<b>DOCKETED</b>	
<b>Docket Number:</b>	19-BSTD-03
<b>Project Title:</b>	2022 Energy Code Pre-Rulemaking
<b>TN #:</b>	235641
<b>Document Title:</b>	Home Ventilating Institute Comments - HVI Comment - Docket No 19-BSTD-03; Response to CEC's Nov 3 Proposal to Establish Minimum Prescriptive Requirements for HERVs
<b>Description:</b>	N/A
<b>Filer:</b>	System
<b>Organization:</b>	Home Ventilating Institute
<b>Submitter Role:</b>	Public
<b>Submission Date:</b>	11/17/2020 12:01:56 PM
<b>Docketed Date:</b>	11/17/2020

**HVI Comment - Docket No 19-BSTD-03; Response to CEC's Nov 3  
Proposal to Establish Minimum Prescriptive Requirements for  
HERVs**

Re: Docket No. 19-BSTD-03, 2022 Energy Code Pre-Rulemaking; *Response to CEC's November 3<sup>rd</sup> Proposal to Establish Minimum Prescriptive Requirements for H/ERVs*

**Figure 1.** A regression of HVI’s H/ERV CPD shows that an SRE of 67 is correlated to an ASRE of 72.

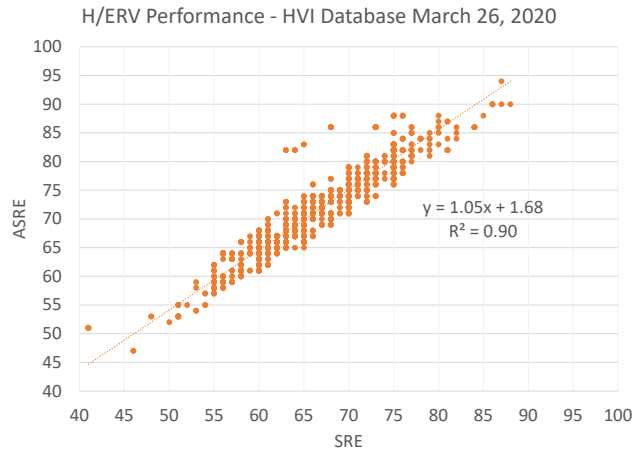
- c. Modification 3: use an Adjusted Sensible Recovery Efficiency (ASRE) when modeling the heat recovery effectiveness of an HVI certified H/ERV, not a Sensible Recovery Efficiency (SRE). The CASE team used a sensible recovery efficiency (SRE) of 67 in their simulations, selected as a value achieved by the majority of H/ERVs in HVI's Certified Product Database (CPD). However, the best metric available to model the performance of an HVI-certified H/ERV when fan energy is calculated separately from heat exchanger performance (as is done within California Building Energy Code Compliance [CBECC] software and EnergyPlus software) is the rated ASRE at a temperature of 32°F. Following is HVI Publication 920's definition of ASRE that is applicable to the rated ASRE at 32°F and that clarifies HVI's recommendation to use an ASRE when conducting building energy simulations:

Communications with CEC staff and Bruce Wilcox on March 27, 2020 confirmed that CEC staff also support the use of ASRE when simulating H/ERV performance in CBECC. Based on a regression of SRE and ASRE values of H/ERVs in the HVI CPD, an SRE of 67 is correlated with an ASRE of 72 (see Figure 1). HVI therefore recommends that CASE's simulations be modified to use an ASRE of 72 when simulating heat exchanger effectiveness.

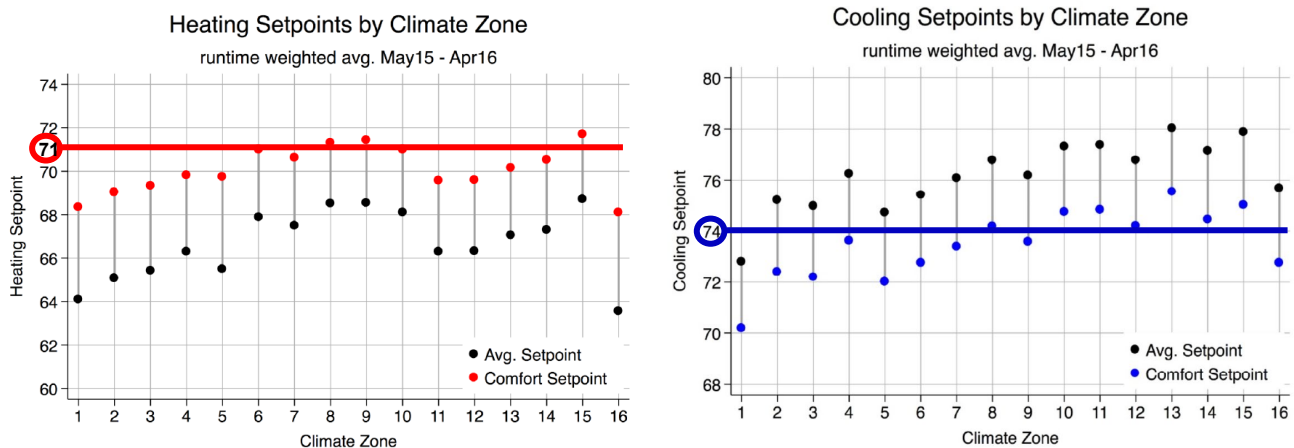
- d. **Modification 4: use thermostat setpoints that are better aligned with occupied setpoints in California homes.** CBECC currently uses a thermostat heating setpoint of 60°F for 8 hours per day and 68°F for 16 hours per day. CBECC’s thermostat cooling setpoint is a constant 78°F in cooling. These setpoints are far more conservative than setpoints assumed by ASHRAE 90.1, IECC, or those documented by a recent study of thermostat setpoints in California homes. As such, CBECC’s setpoints discount the heat recovery benefit of H/ERVs that when modeled within CBECC. A 2016 study conducted by Nest<sup>3</sup> across 150,000 California residential thermostats and 13 million days of data identified a thermostat “comfort set point” in heating and cooling, which was the “typical setting when people are home and want to be comfortable”. Arguably, occupancy and comfort-driven behavior are reasonable bases for establishing thermostat setpoints for a building energy standard. Because it is an occupied comfort setting, the comfort setpoint identified by Nest is higher than the average setpoint and is determined as “the 90<sup>th</sup> percentile of the customer’s heating set points and the 10<sup>th</sup> percentile of their cooling set points” for each climate zone. The state-wide comfort setpoints attributed to the Nest study in Table 2 are values that have been developed by applying a multifamily-starts weighting factor for each climate zone (derived from CEC data) to the Nest study’s comfort setpoint for each climate zone. Figures 2 and 3 show both the average and comfort heating and cooling setpoints for each climate zone (Nest data) as well as estimated, weighted state average heating and cooling setpoints (developed from post-processed Nest data). While HVI recommends the use of occupied comfort setpoints for CBECC analysis, it is clear even from the average thermostat setpoints in the Nest data that CBECC’s thermostat heating setpoint should be revised upward and CBECC’s cooling thermostat setpoint should be revised downward, resulting in greater energy savings for H/ERVs than predicted by the CASE study.
